## Errata Sheet

### SLG46140

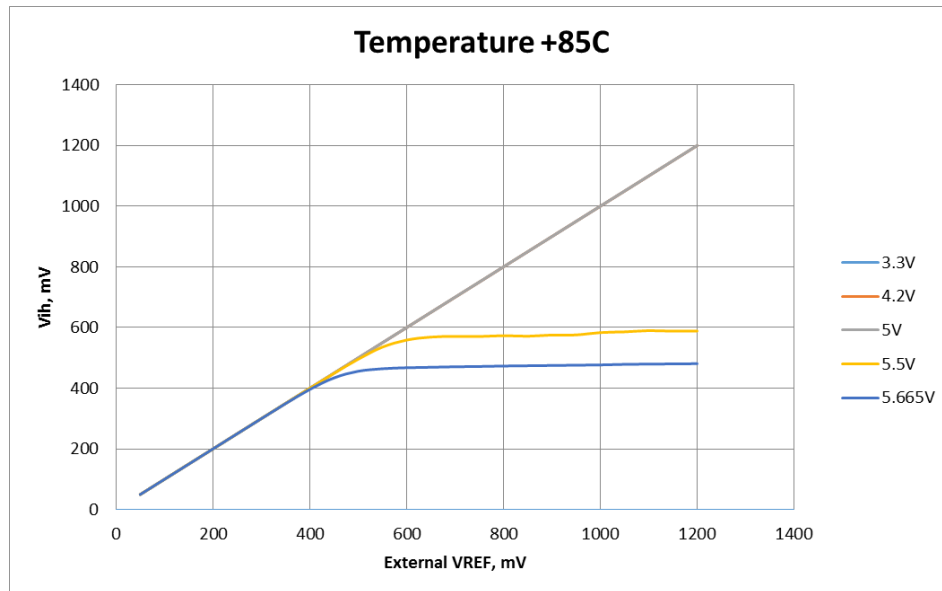
#### ISSUE 1: ACMP Output is Inaccurate when using External Vref at High VDD and Temperature Functional Block Affected: ACMP

When using external Vref source, the ACMP comparison may happen at wrong threshold if the external Vref voltage is higher than a particular value (please see figure below) at high VDD values ( $> 5V$ ) and high temperature.

Avoid using ACMPs in such conditions.

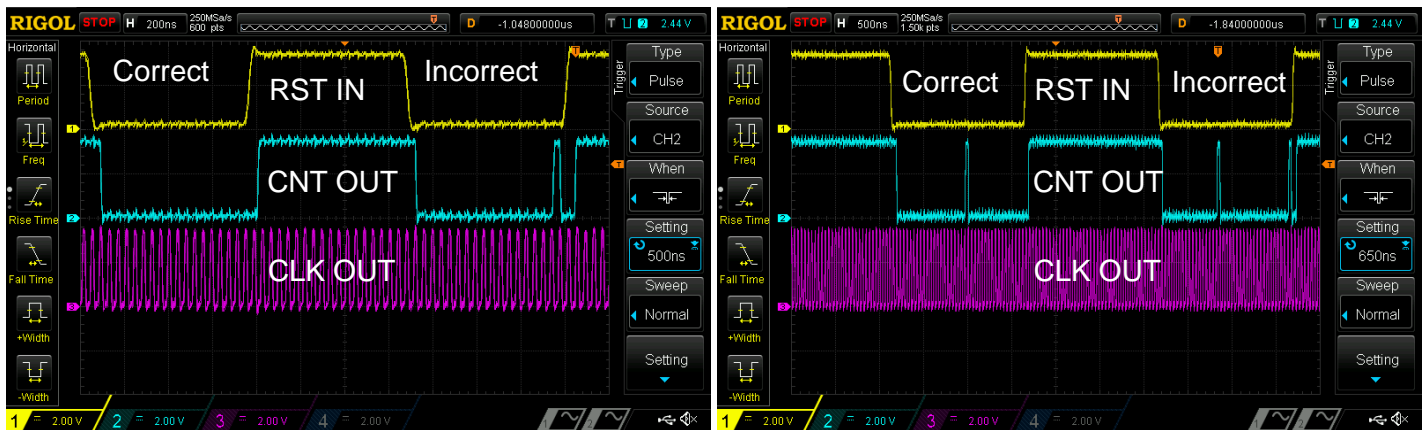
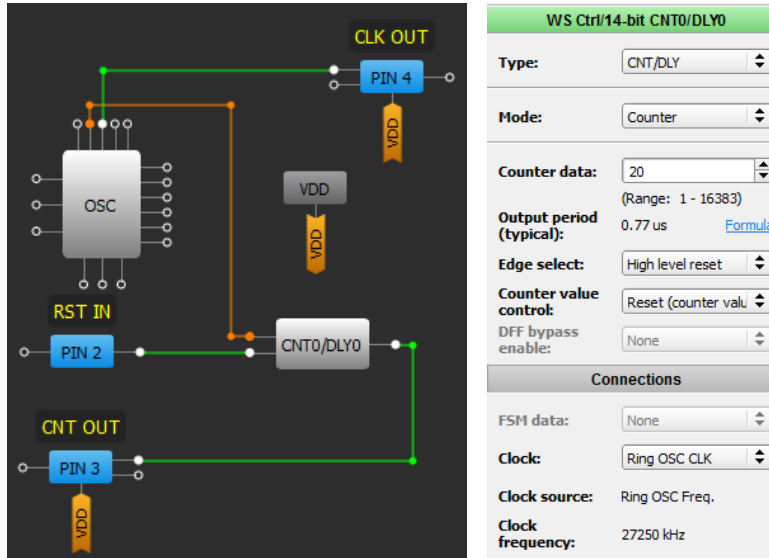
#### ISSUE 2: Incorrect Counter Operation after the Reset Functional Block Affected: Counter

If the Counter Reset occurs at a time very close to a rising edge of the clock signal during clock signal generation (for example OSC operation), there is a possibility that the Counter Data of the Counter is reset incorrectly and the counter end signal (HIGH pulse) may appear faster than expected. This phenomena appears more frequently the higher the clock frequency is.

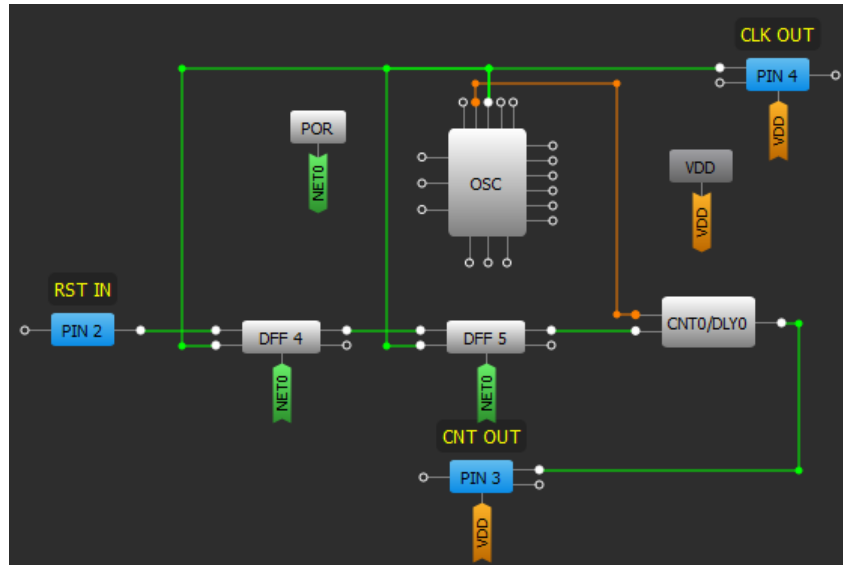
- Synchronize RESET input of the Counter with its CLK using 2 DFF cells as shown in the image below.

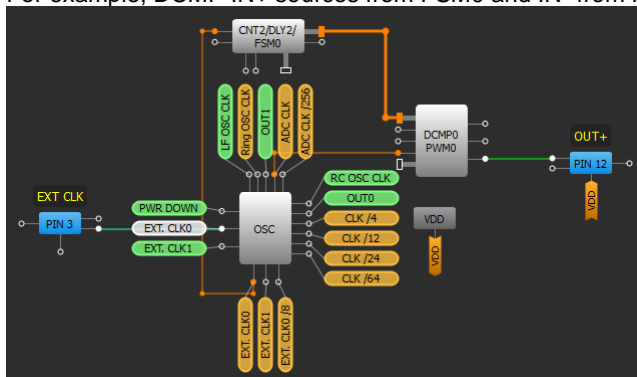
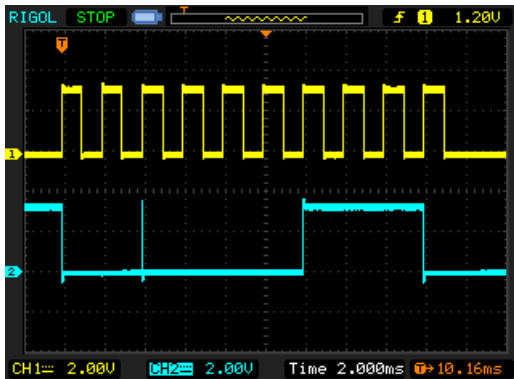
### ISSUE 3: DCMP OUT+ Output Glitch

DCMP's OUT+ output may have a glitch when the input data is changed. This issue appears more frequently the higher the DCMP clock is.

For example, DCMP IN+ sources from FSM0 and IN- from Register0. DCMP is clocked from the Ring OSC.

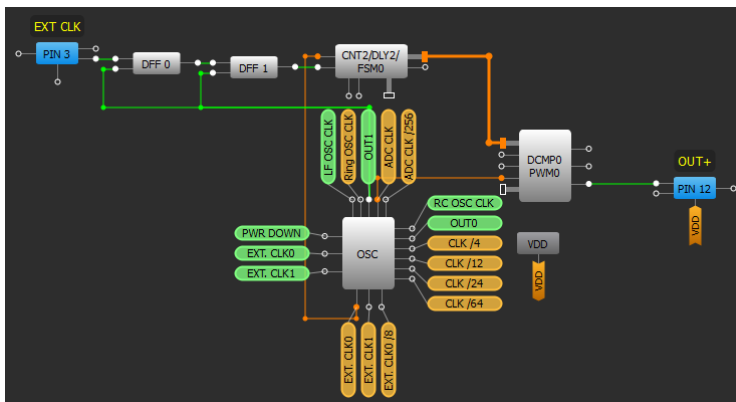
- Synchronize the data source clock with the DCMP clock source using 2 DFF cells as shown in the image below.

Channel 1 – ACMP out  
Channel 2 – WS\_OUT

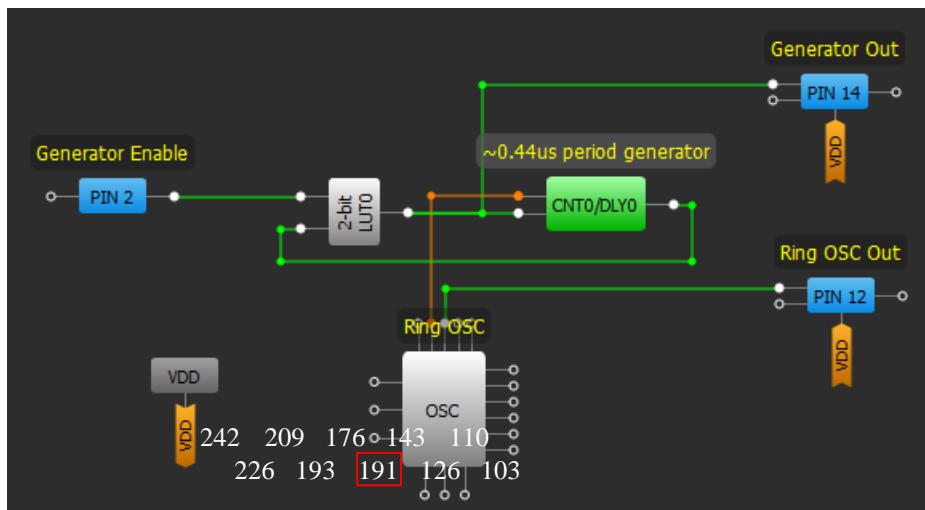
### ISSUE 6: ACMP Output Glitch due to Ring OSC Operation Functional Blocks Affected: W/S Control, ACMP

The output of the ACMP incorrectly goes low even when IN+ is greater than IN- if the RING OSC is active when the WS signal rises

- Avoid using the RING OSC with the WS Controller, or add a filtering block on the ACMP output to filter out the glitch.

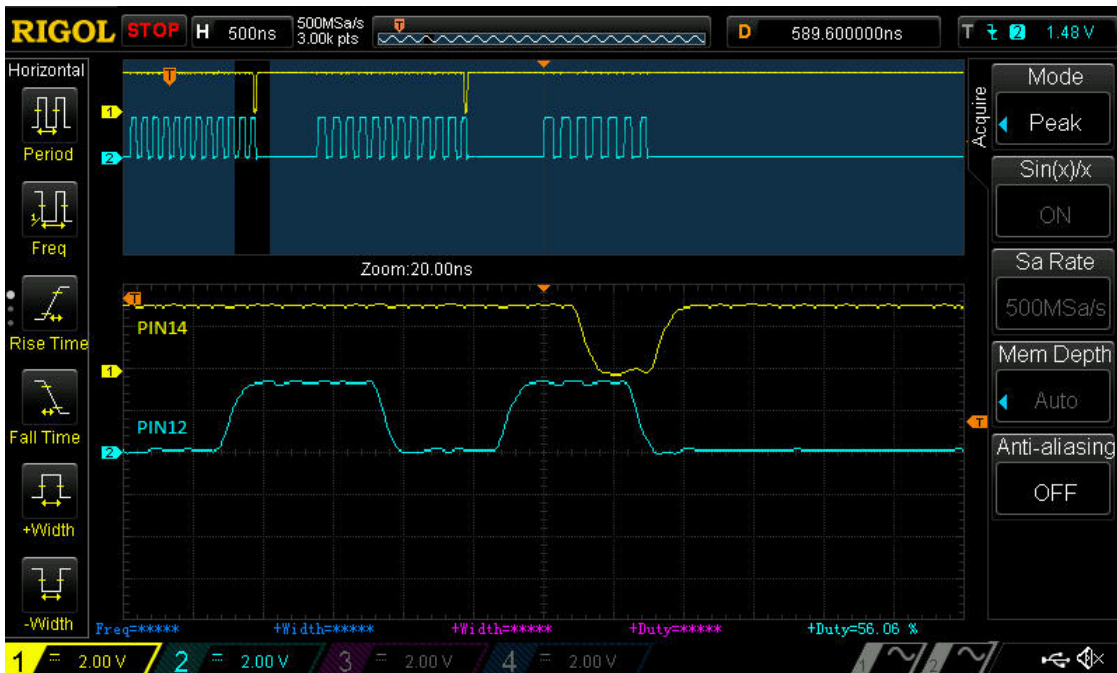
### ISSUE 7: Long Ring OSC Settling Time Functional Block Affected: Ring OSC, Delay, Counter

The Ring OSC has a longer settling time when configured as Auto Power On in the designs that have very short Ring OSC disable time. An example of such issue is in the following configuration:

The configuration shown above generates a periodical signal with a frequency defined by the Delay cell and started by a high signal on PIN2. The issue becomes apparent in a longer settling time when the scheme generates short pulses (Delay is configured as a rising edge delay only). See waveform below.

- Set Ring OSC power mode to “Force Power On”
- or, Set Turn on by register option in BG (Band Gap) block as “Enable”

Channel 1 – 2-bit LUT0 output; Channel 2 – Ring OSC output

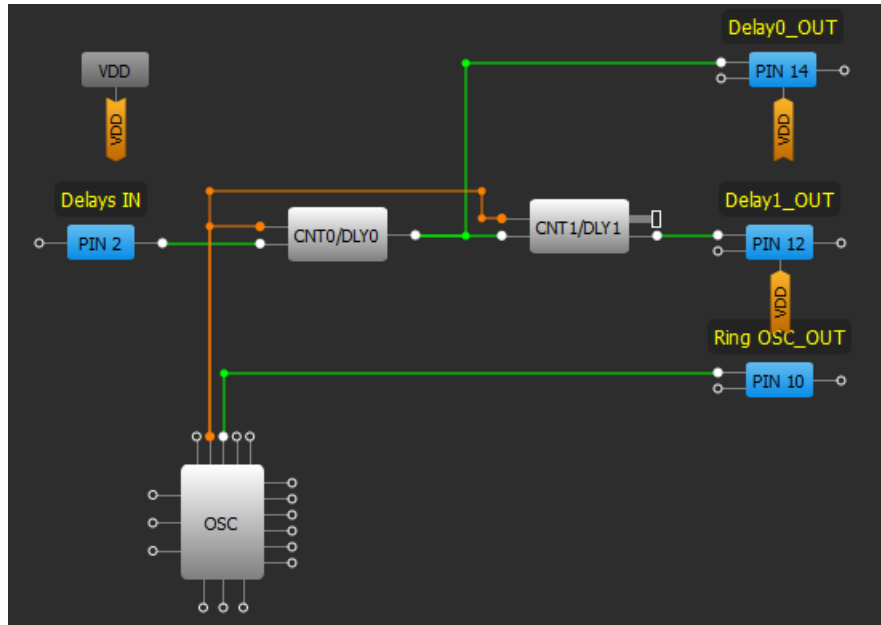
Such behavior will lead to substantial error in period calculations if the delay time is relatively small.

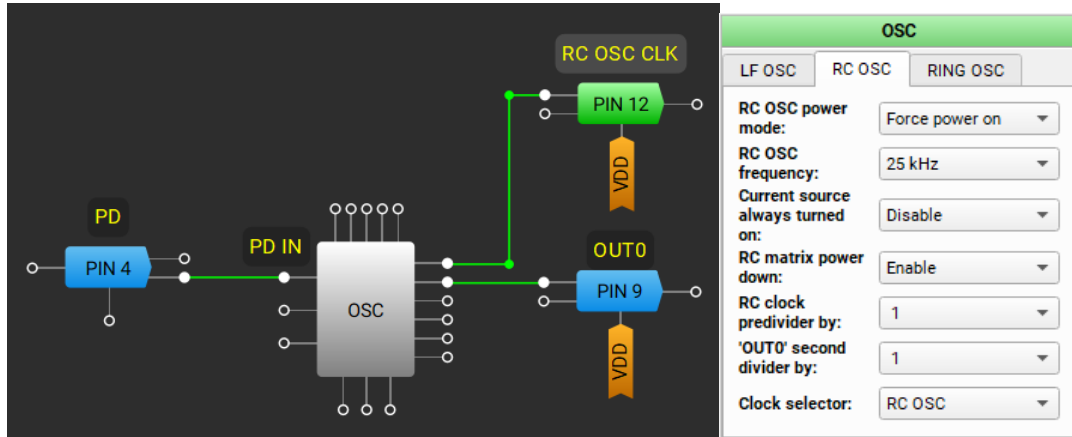
If a pulse with a duration of less than ~40 ns is applied to the PWR DOWN input of an oscillator, the oscillator outputs remain stuck for milliseconds.

The issue is observed for all available oscillators.

Avoid applying glitches to the PWR DOWN input of an OSC.

1.9 kHz OSC long start-up:

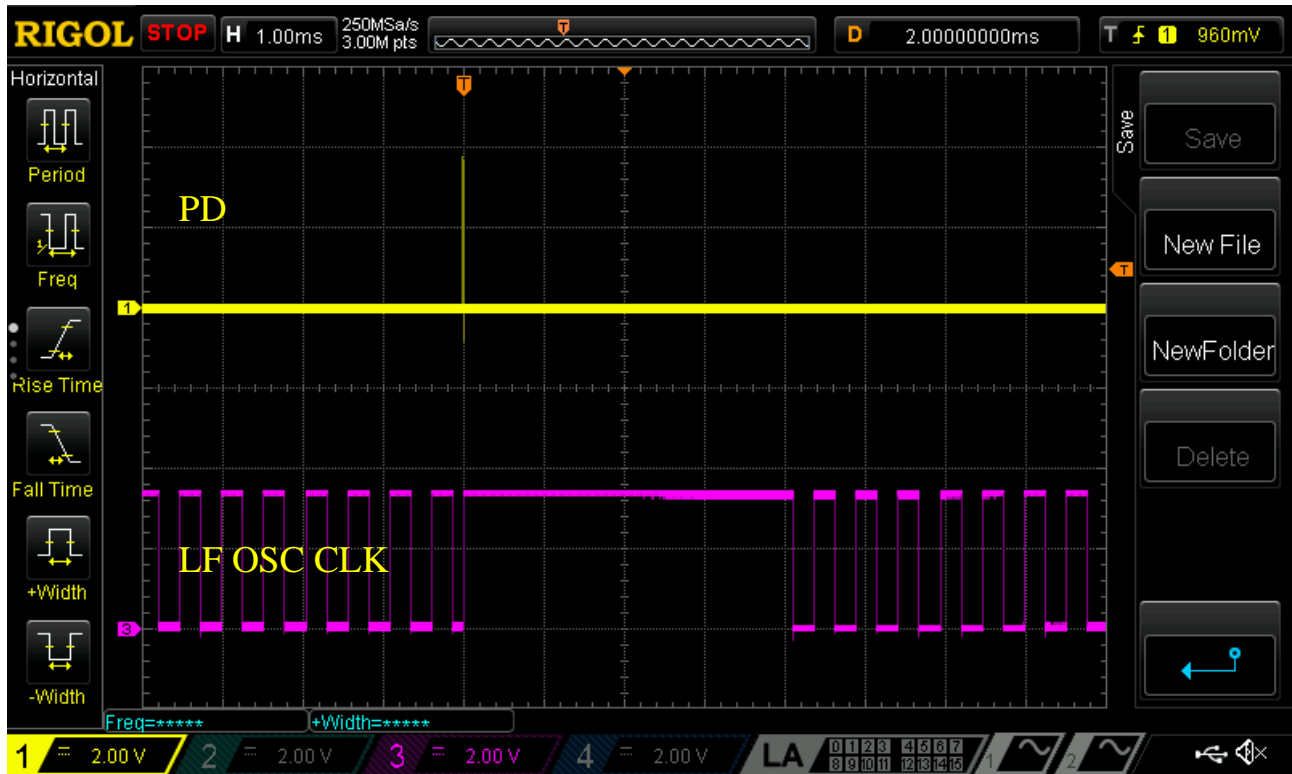
#### **ISSUE 10: OSC Long Start-Up Time** **Functional Block Affected: OSCs**
